Informal document GRRF-80-31 80th GRRF, 15-18 September 2015, Agenda item 6

Proposal to introduce requirements for the approval of replacement brake discs for L-category vehicles in UN Regulation No. 90

(Revision 2)

Today (80° GRRF session), ITALY is thus willing to propose a **Revision 2** of the proposal: **ECE/TRANS/WP.29/GRRF/2014/23/Rev.2**

Table A14/5.1.4.1.2.

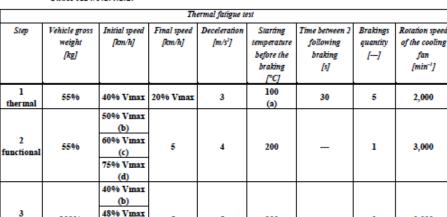
5.1.4.1.2 Fatigue test

According Table A14/5.1.4.1.2.

Steps from 1 to 3 = 1 cycle; repeating for a total of 20 cycles (= 160 brakings)

Starting temperature of the 1° braking only

- Disc diameter < 240 mm
- Disc diameter ≥ 240 < 280 mm
